ADDENDUM NO. 1

October 3, 2024

Whiteland High School Ph 2: Café Kitchen Band Choir Auditorium
300 E. Main Street
Whiteland, IN 46184

SHEET 303

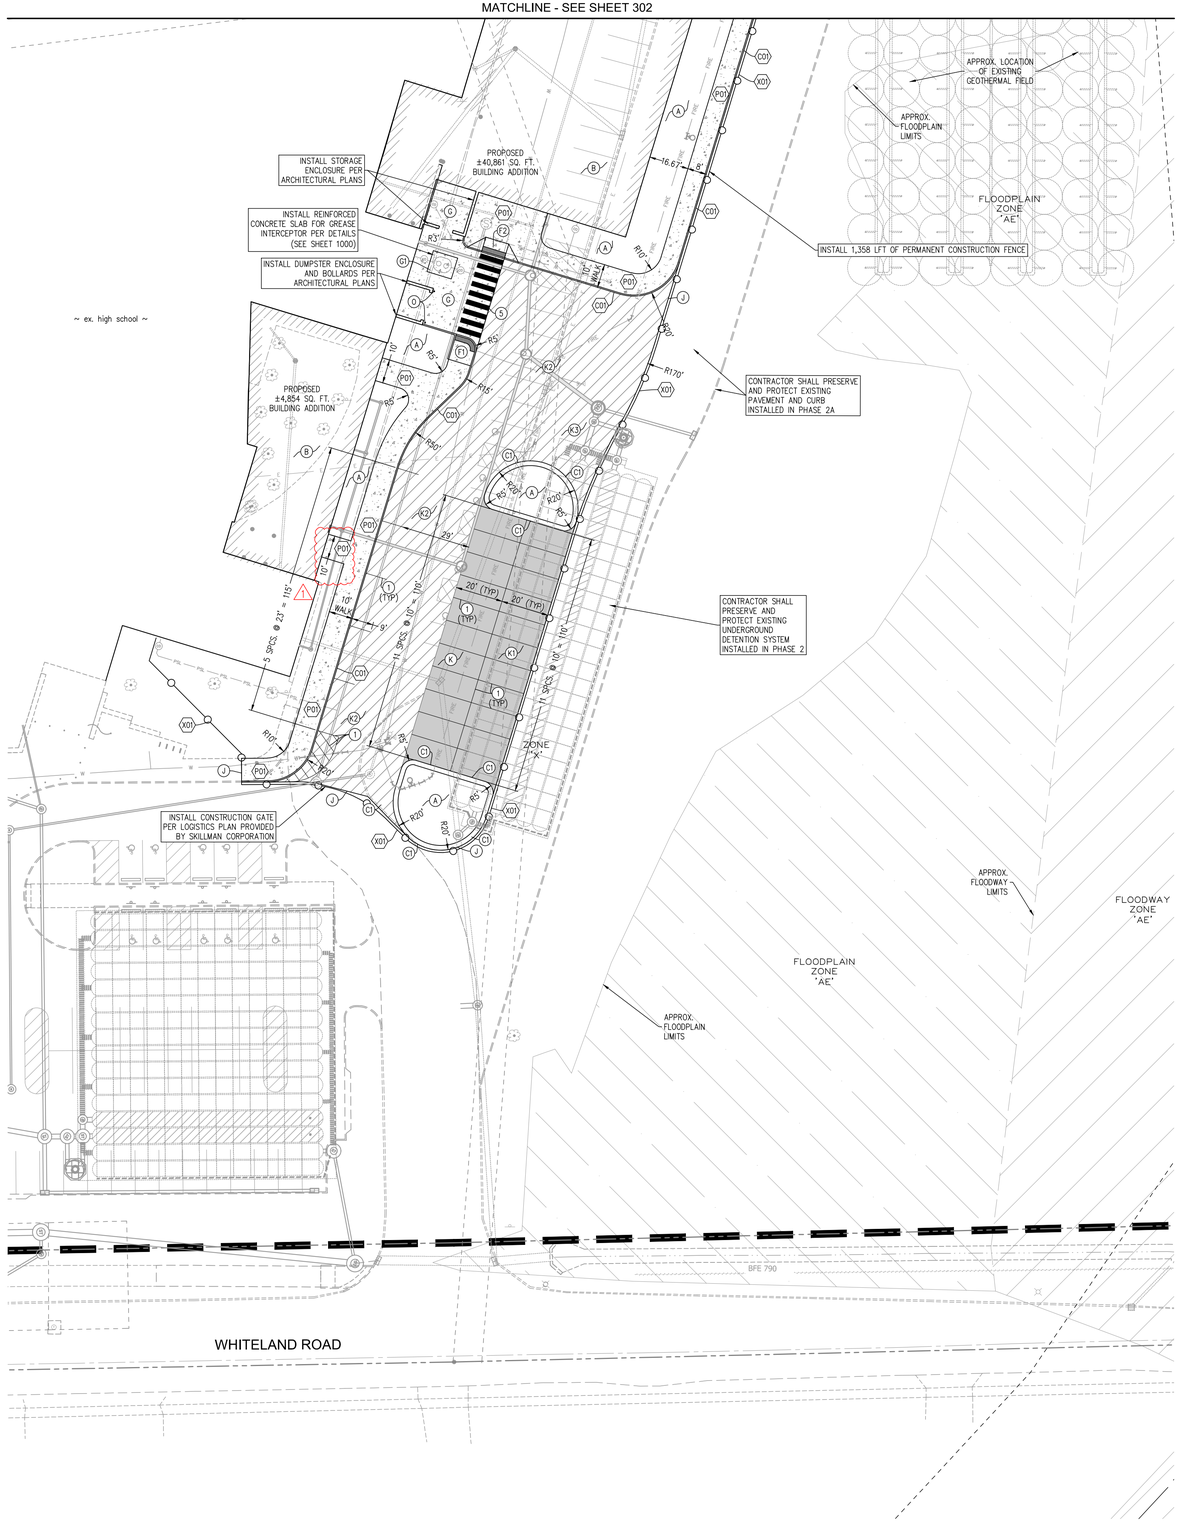
4. Site Dimension Plan (sheet 303):
- Revised location of sidewalk into cafeteria addition based on architectural floor plan.

SHEET 403

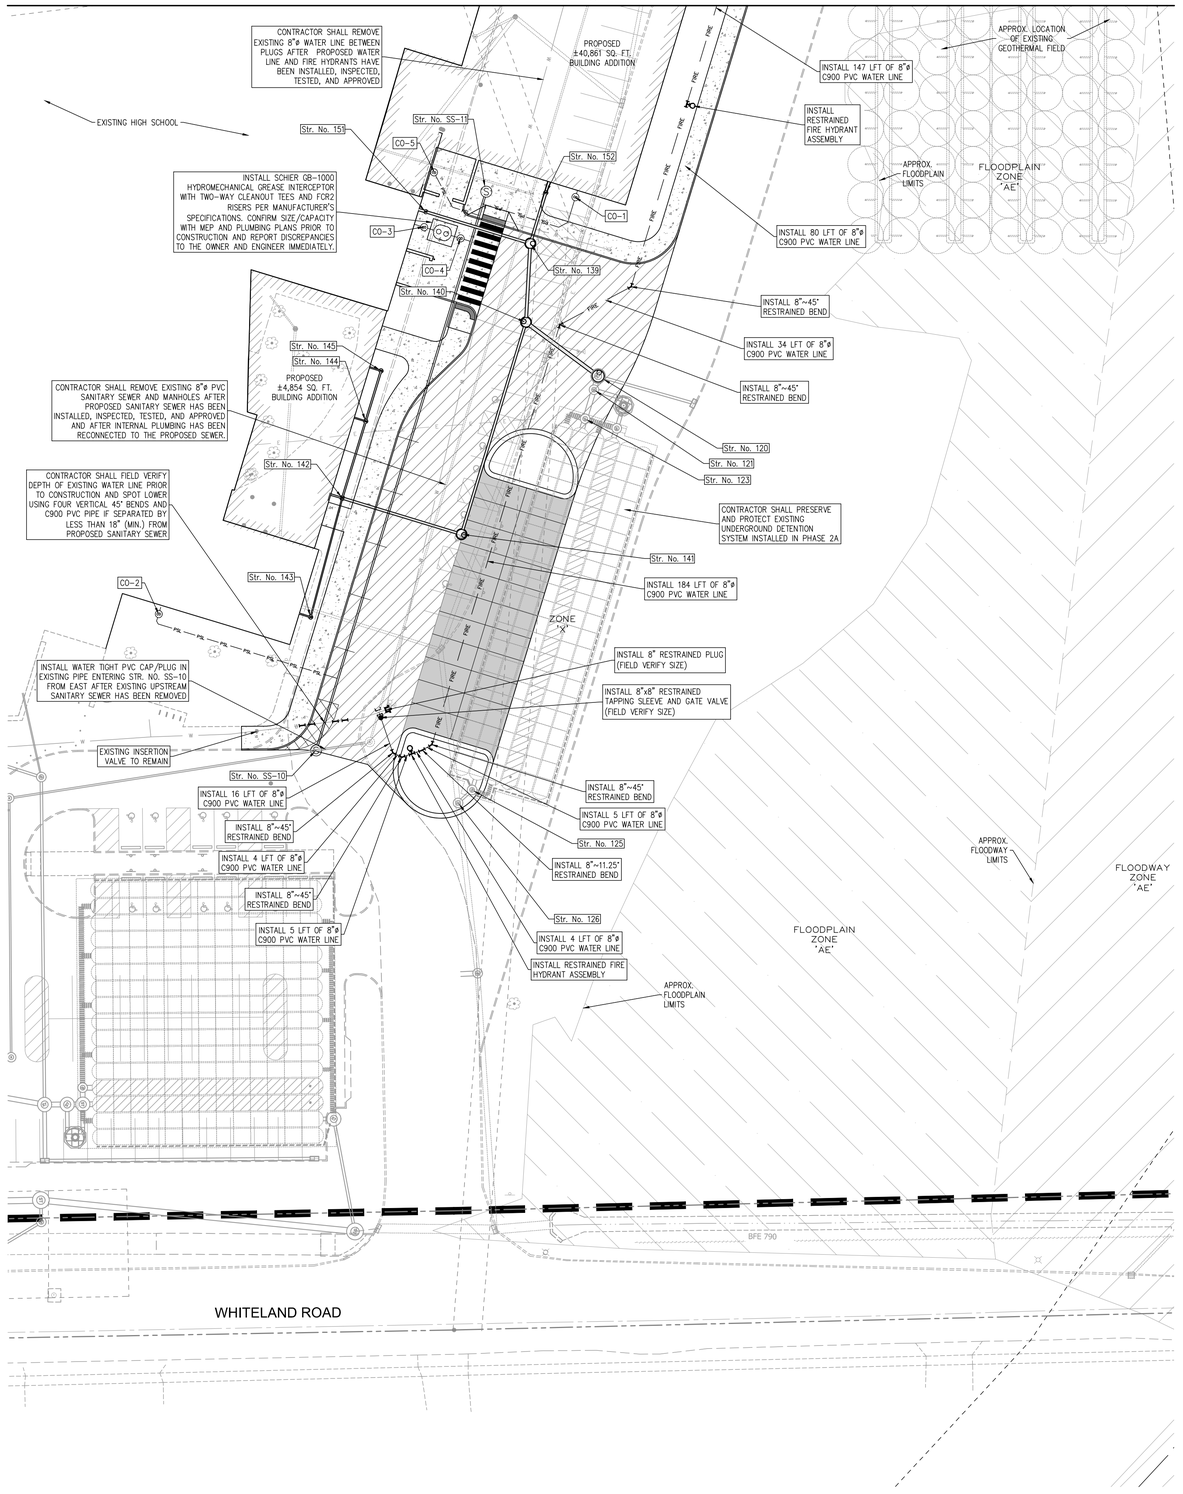
7. Utility Plan (sheet 403):
- Increased pipe diameter from 6" to 8" schedule 40 PVC pipe for Str. No. 144 and 145 and flattened pipe slopes.

SHEET 503

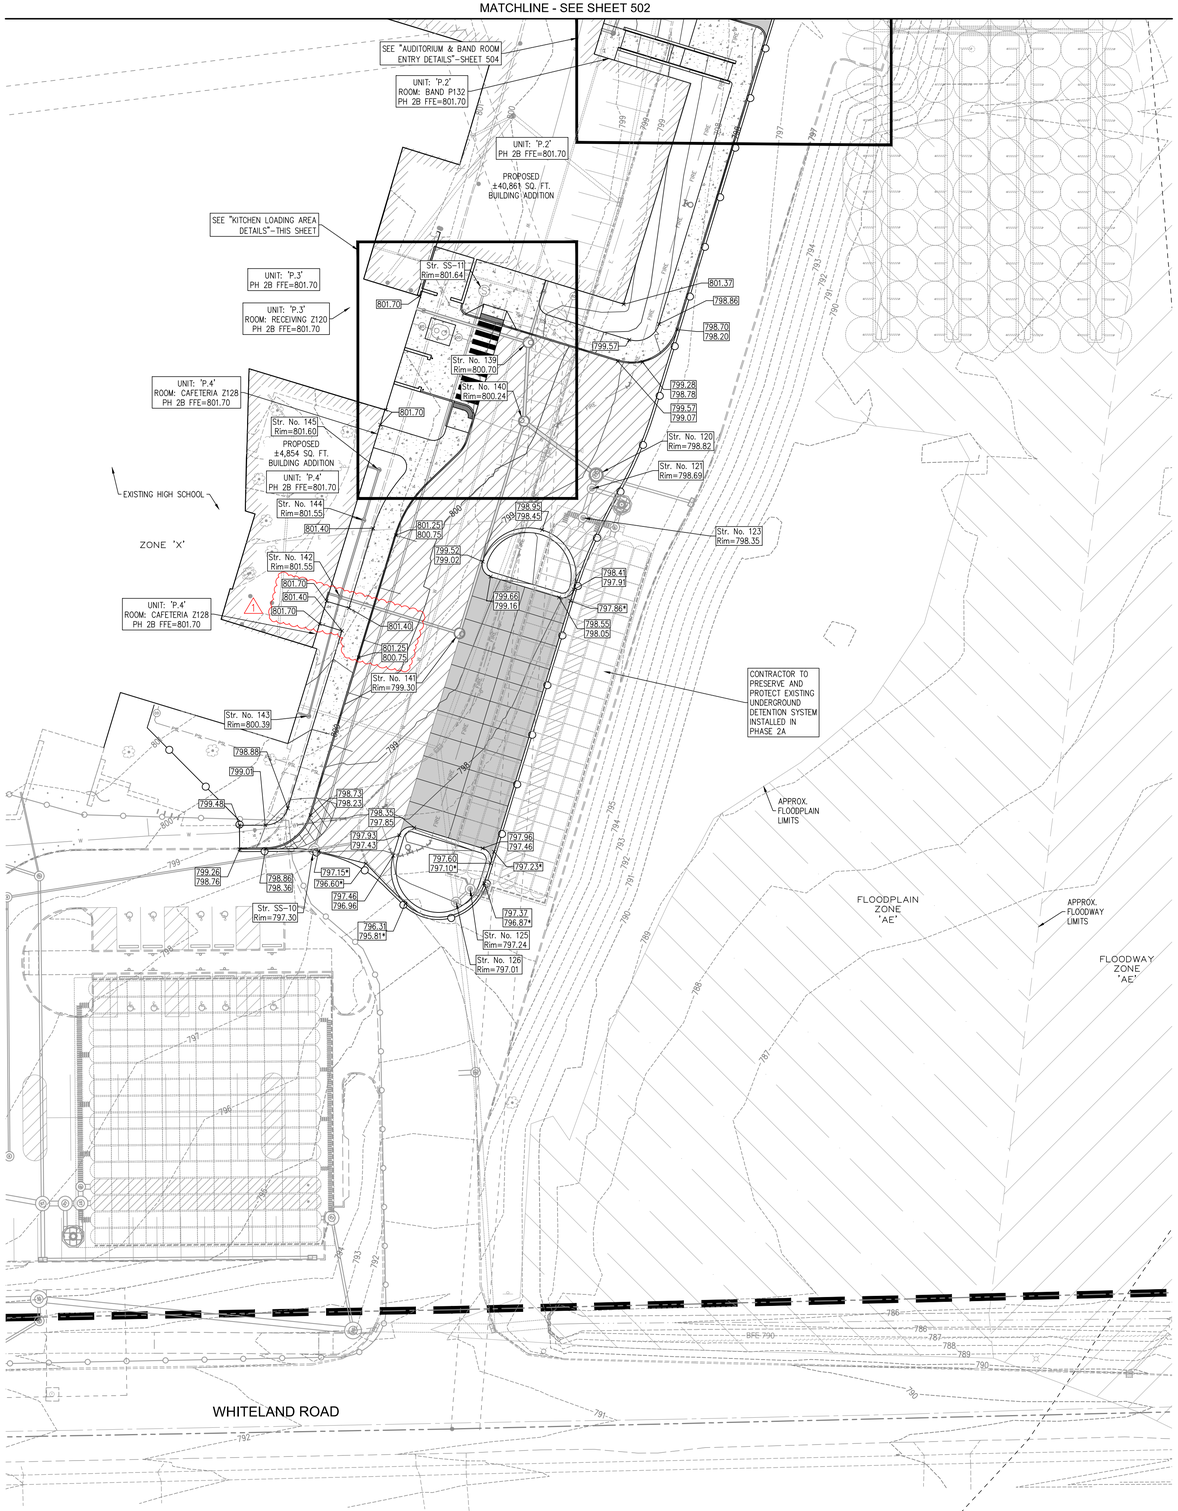
8. Grading Plan (sheet 503):
- Revised grading of sidewalk into cafeteria addition based on architectural floor plan.

SHEET 801

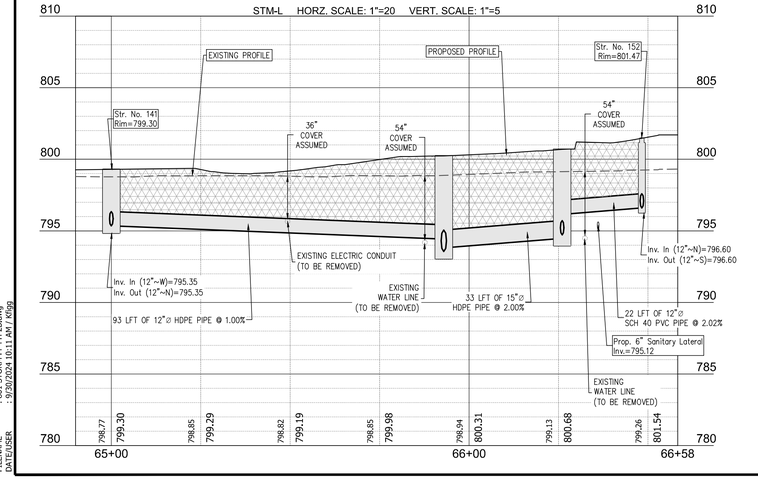
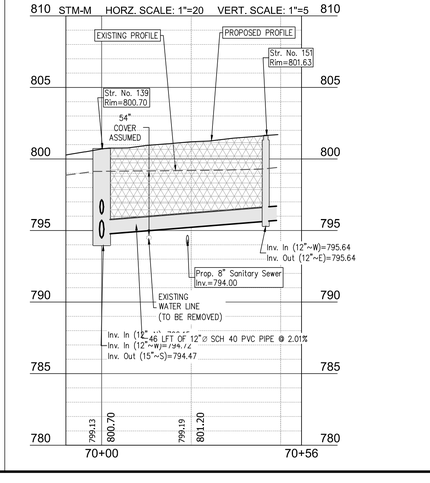
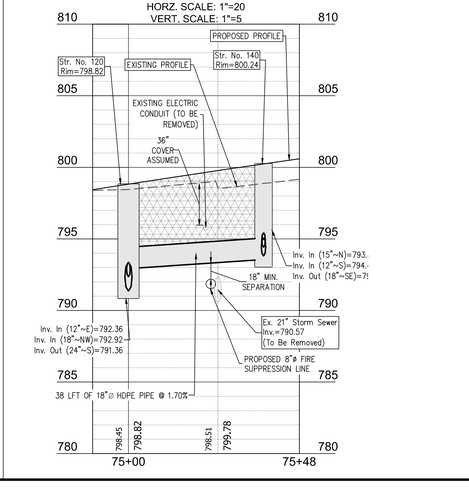
10. Storm Plan & Profile (sheet 801)
- Revised profile "STM-K" to show increased pipe diameter from 6" to 8" schedule 40 PVC pipe for Str. No. 144 and 145 and flattened pipe slopes.

SHEET 900

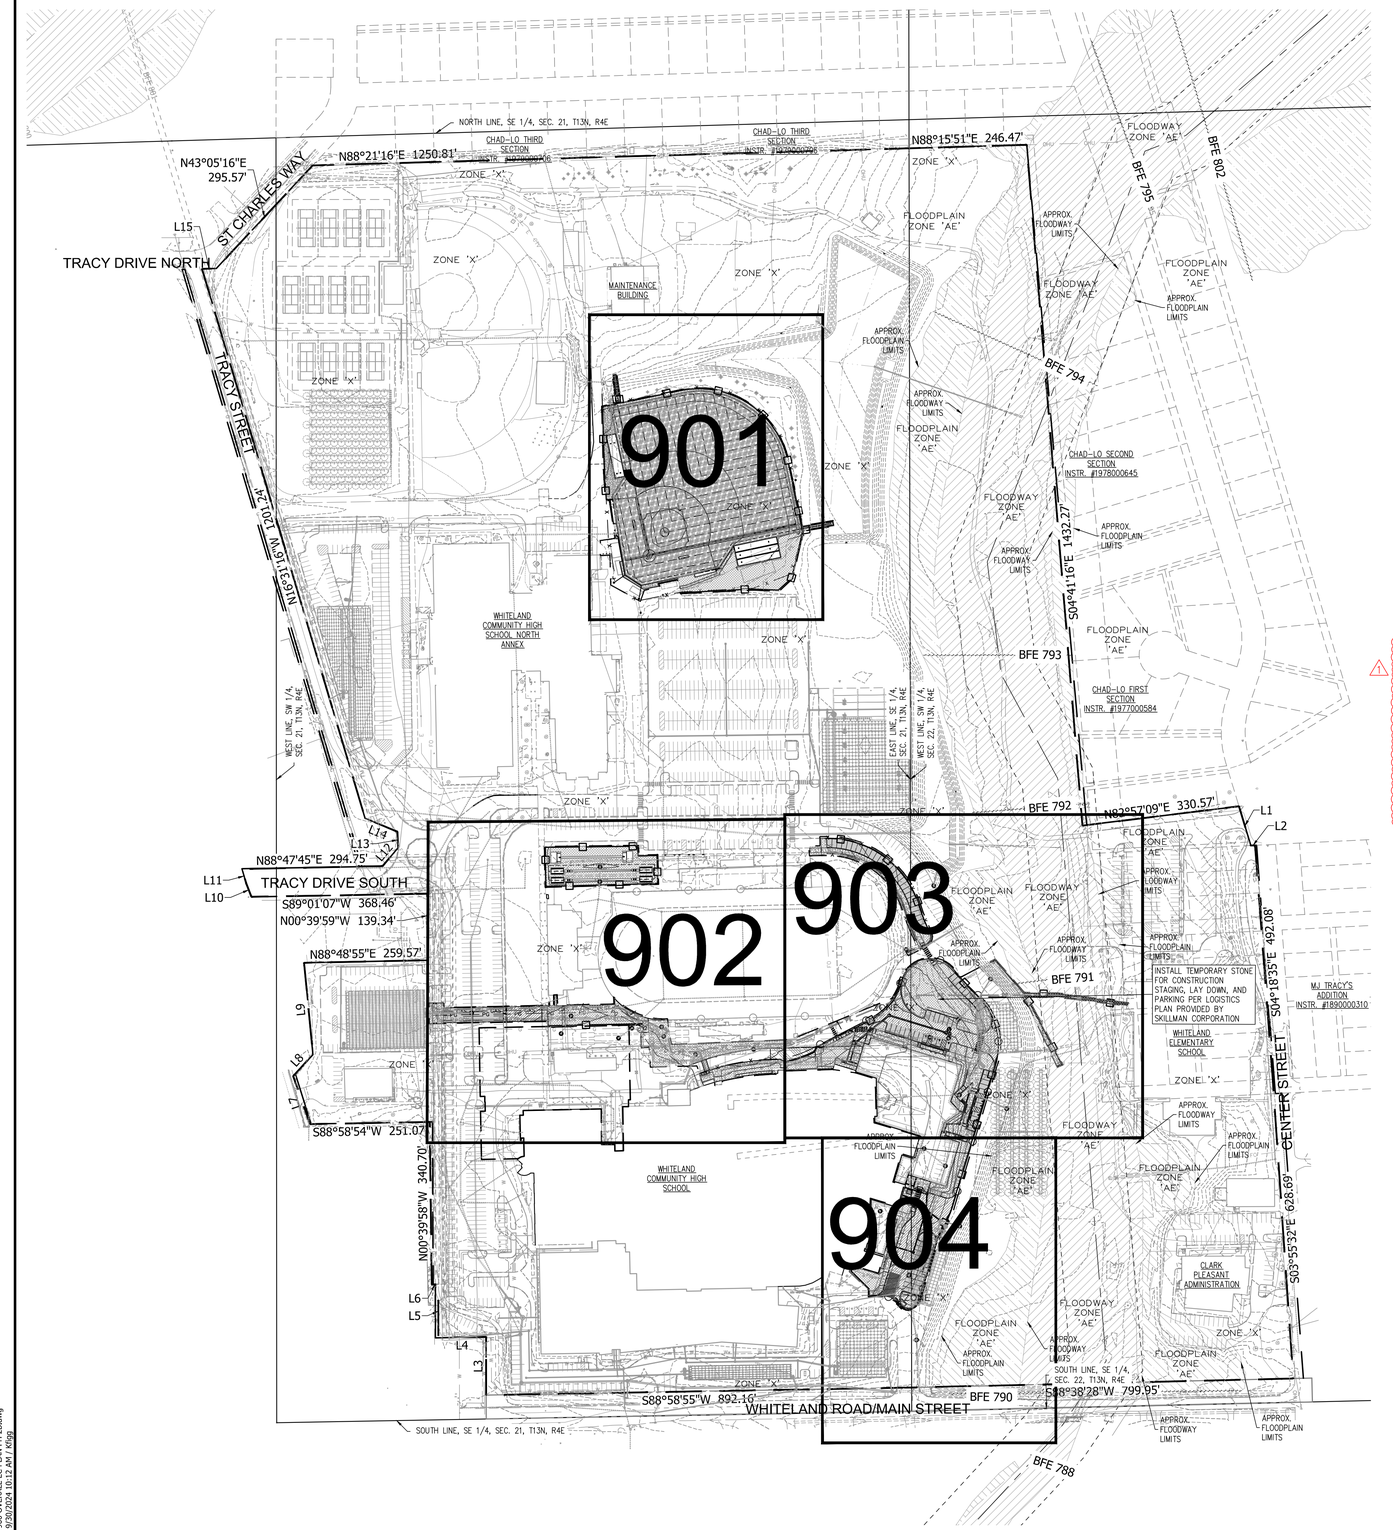
11. Overall Erosion Control Plan (sheet 900):
- Added note #6 to Erosion Control Notes regarding street sweeping.

SHEET 901

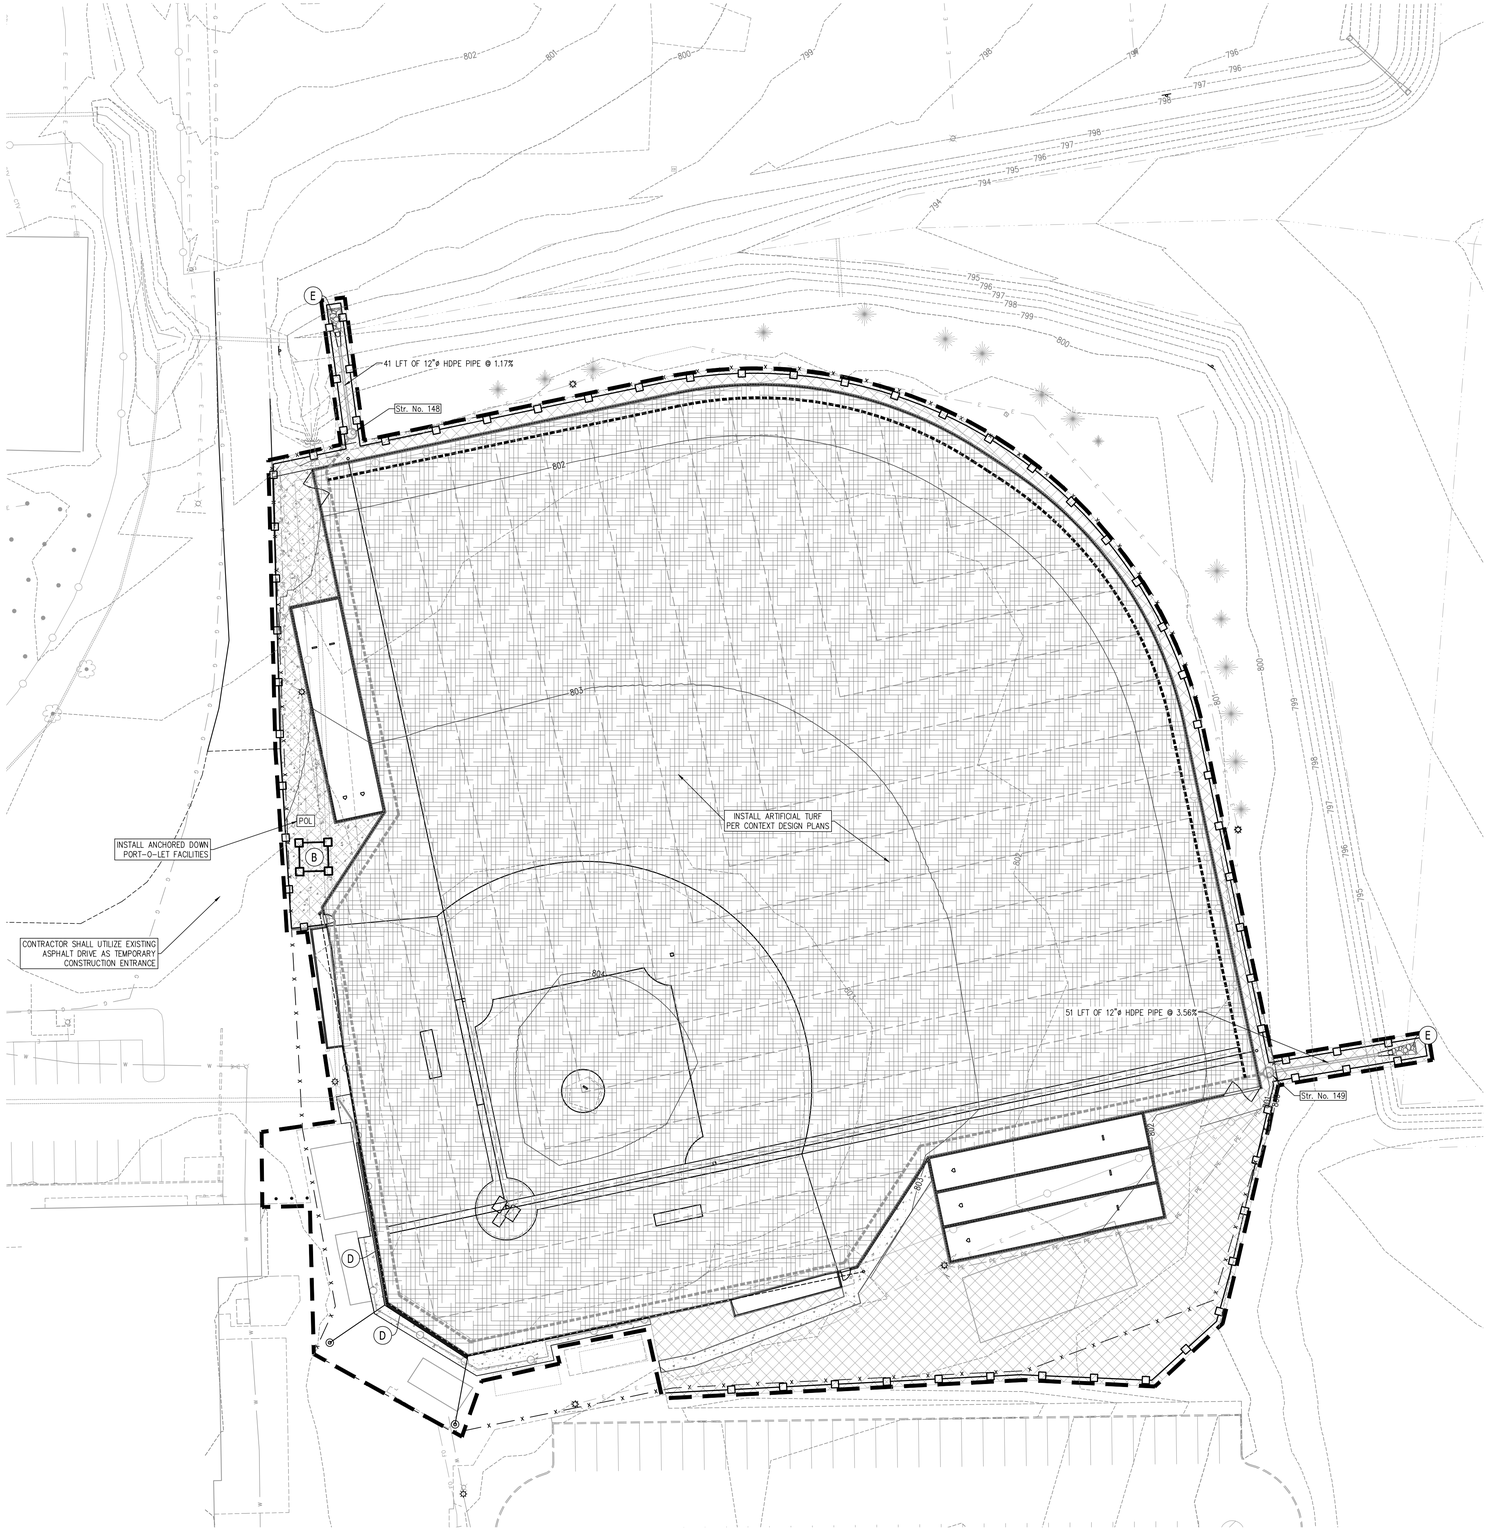
12. Erosion Control Plan (sheets 901, 902, and 904)
- Added note #6 to Erosion Control Notes regarding street sweeping.
